From: Amy.Furness [redacted]
Sent: Wednesday, October 8, 2025 6:15 pm
To: Kate.Turner [redacted]
Subject: DISC/25/0226 - Condition 10 and 6

Drawing No: Con. 6. Drawn on 03.07.2025. Drawing No: CIV-100, Revision A02, Updated: 11.06.25 (Provided within Letter "prepared in response to Lead Local Flood Authority comments dated 09.04.2025…').

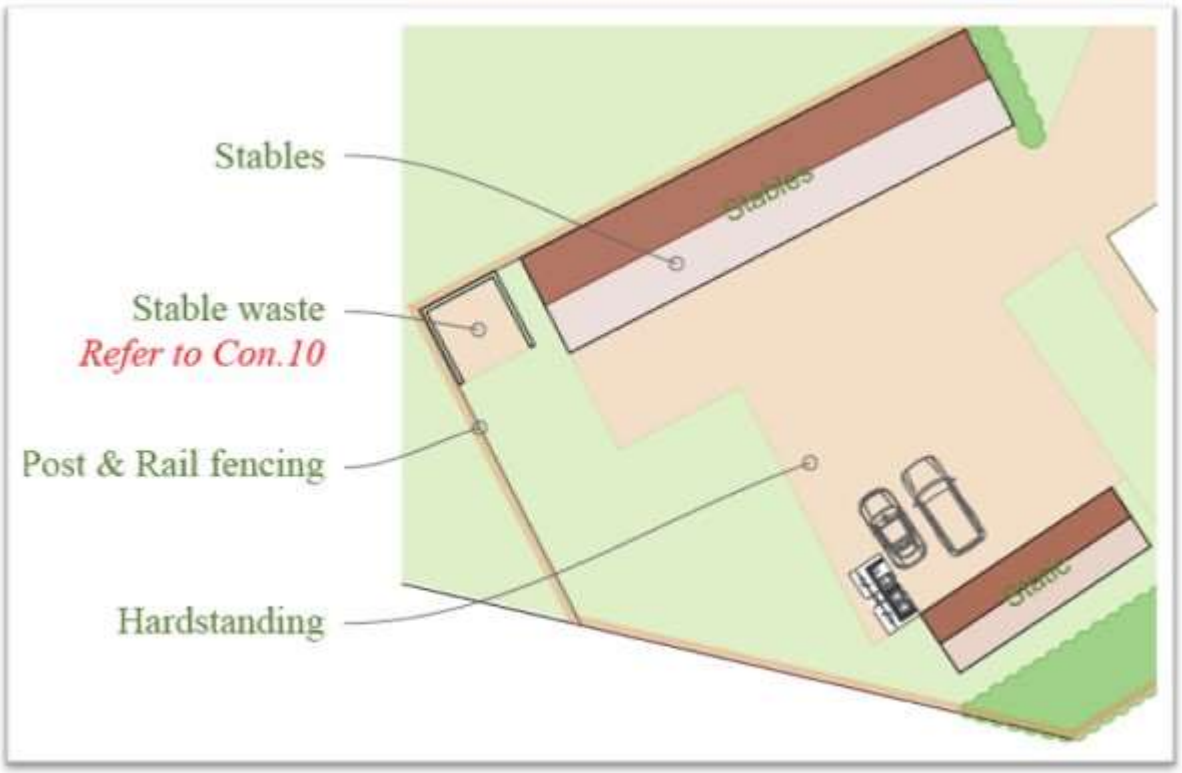
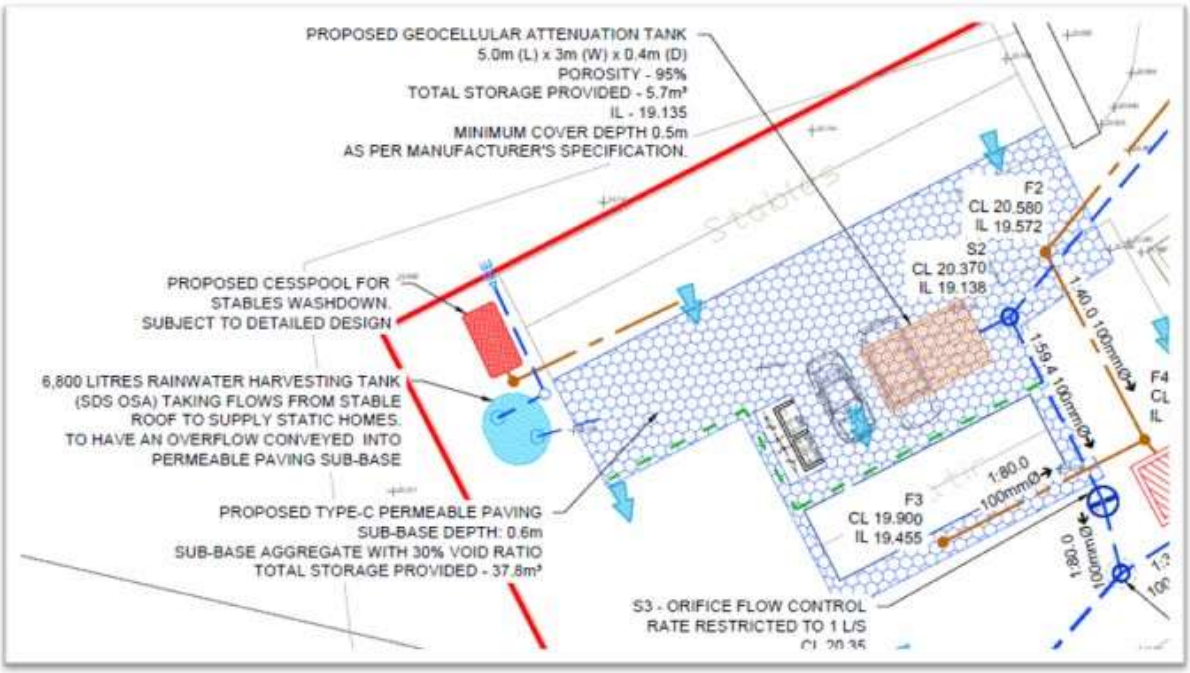
- The stable waste block was not included within the Drainage Strategy and as such, surface water runoff from this stable waste block has not been considered within the drainage strategy.

- The proposed location of the stable block is on top of the proposed location for the cesspool for the stables washdown area. This is not appropriate – there is concern here regarding accessibility to empty and maintain the cesspool, as well as the cumulative load bearing down onto it from the stable waste above. Should the cesspool be compromised, the resulting runoff from the stables washdown area may flow towards the ditch or into the permeable paving, resulting in contaminated water ultimately making its way into the ditch at the outfall location. This poses an environmental health concern regarding contamination to the resulting watercourse. **I therefore recommend that the stable waste block be moved to a different location.**

- I note that the proposed drainage layout plan stated *'Proposed cesspool for stables washdown. Subject to detailed design.'* It was believed by HDC Drainage that this information would be provided separately to discharge condition 10. **It is crucial that the cesspool is sized appropriately and emptied frequently**. Should the cesspool overflow, the resulting runoff from the stables washdown area may flow towards the ditch or into the permeable paving, resulting in contaminated water ultimately making its way into the ditch at the outfall location. This poses an environmental health concern regarding contamination to the resulting watercourse.

- The proposed location of the rainwater harvesting tank lies beneath the route which would be taken to empty waste into the stable waste block. The plans do not indicate the depth of the proposed rainwater harvesting tank nor plans to reinforce the surface above to stabilise the ground should a vehicle drive over, which may be the case to empty the stable waste storage block. I do NOT advise that vehicles are allowed to drive over the area of the rainwater harvesting tank, including those accessing the

stable waste block. **I therefore recommend that the stable waste block be moved to a different location.**

- **The proximity of the proposed cesspool to the rainwater harvesting tank has been highlighted as a concern by Environmental Health – please consult Environmental Health – a revision of the location of the rainwater harvesting tank may be necessary to put more distance between the rainwater harvesting tank and the cesspool.**

In light of this information, I highly recommend a revision to the layout of the stable waste block, the rainwater harvesting tank and the cesspool, considering access to and maintenance of the cesspool and stable waste block.
